Access Compliance Report Public Rights-of-Way (Curb Ramps)

Main Street: WILSON_ST Cross Street: MADISON_AVE Location: NE

ADA ID: RPRK211004121332 Ramp Type: Type 1 - Perpendicular Diagonal Initial Pass/Fail: Fail Overall Compliance: No Severity Score: 15

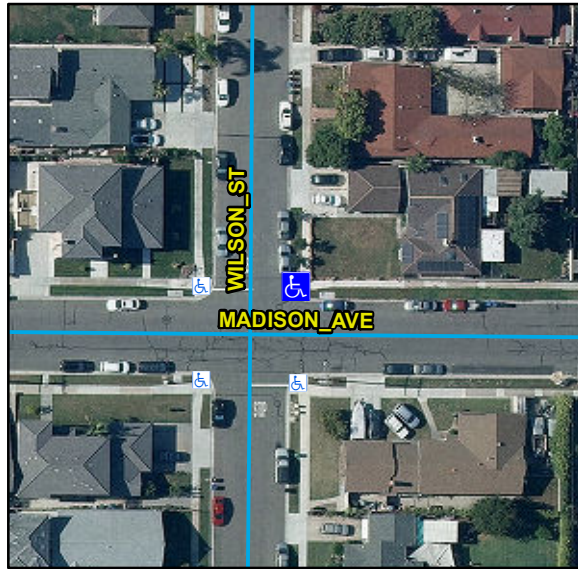
Compliance	Description	Data	Compliance	Description	Data
N/A	Ramp Length (in)	100	N/A	Flare Type LT	
Yes	Ramp Width (in)	48			N/A
No	Ramp Run Slope (%)	10.2	N/A	Flare Slope LT (%)	N/A
Yes	Ramp Cross Slope (%)	1.4	N/A	Flare Traversable LT	N/A
N/A	Landing Present	N/A	N/A	Flare Type RT	
N/A	Landing Length (in)	N/A			N/A
N/A	Landing Width (in)	N/A	N/A	Flare Slope RT (%)	N/A
N/A	Landing Run Slope (%)	N/A	N/A	Flare Traversable RT	N/A
N/A	Landing Cross Slope (%)	N/A	N/A	DWS Provided	N/A
N/A	Landing Movement Obstructed?	N/A	N/A	DWS Contrast	N/A
	Landing Movement Type	N/A	N/A	DWS Length (in)	N/A
N/A	Landing Shared	N/A	N/A	DWS Full Width	N/A
N/A	Clear Space	Yes	N/A	DWS Offset Left (in)	N/A
N/A	Clear Space To Crosswalk (in)	N/A	N/A	DWS Offset Right (in)	N/A
N/A	Marked Crosswalk 1	No	N/A	Marked Crosswalk 2	No
	Crossing 1 Direction	W		Crossing 2 Direction	S
	Marked Crosswalk 1 Width (in)	N/A		Marked Crosswalk 2 Width (in)	N/A

Remove & Replace Curb Ramp With Two New Directional Ramps or Equivalent.
